OIL FILTER / ELECTRA GLIDE, SPORTSTER

HARLEY-DAVIDSON MOTOR CO., INC.

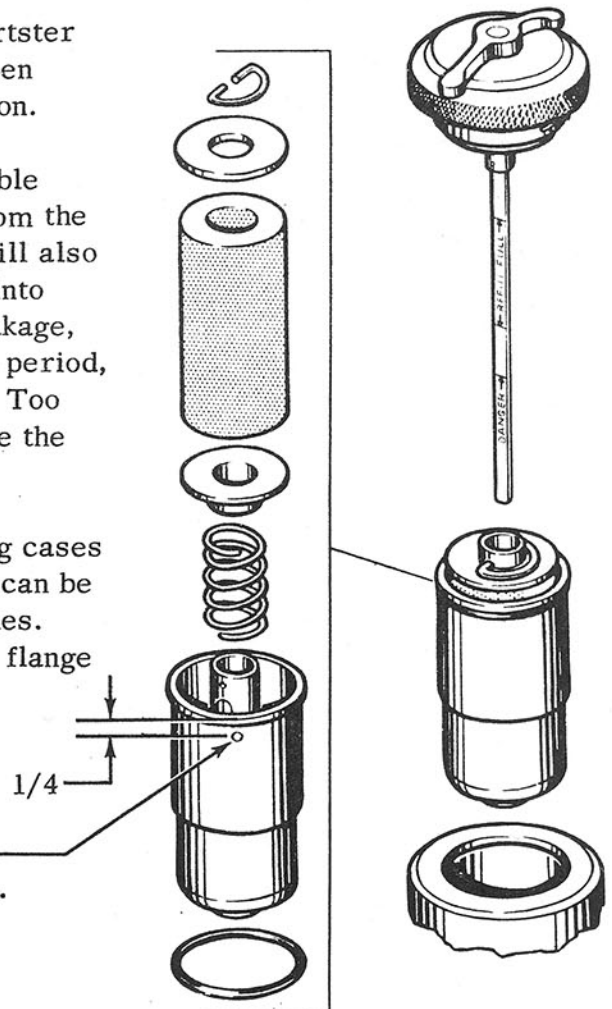
Starting with production Electra Glides and Sportster XLH models on June 9, 1969, a vent hole has been added to the filter cup as shown in the illustration.

The purpose of this hole is to relieve any possible pressure buildup in the tank which forces oil from the tank when the cap is removed. The vent hole will also prevent possible siphoning of oil from the tank into the engine after the engine is stopped. Such leakage, while the engine is not operated for an extended period, could find its way into the primary chain case. Too high an oil level in the chain case would saturate the clutch linings.

To prevent this possibility or to correct existing cases of tank pressure or siphoning, a 1/16 dia. hole can be drilled in the oil filter cup on earlier motorcycles. The hole should be drilled 1/4 in. below the top flange as shown in the illustration.

Drill vent hole (1/16 dia. drill) thru side of cup, 1/4 in. below flange.
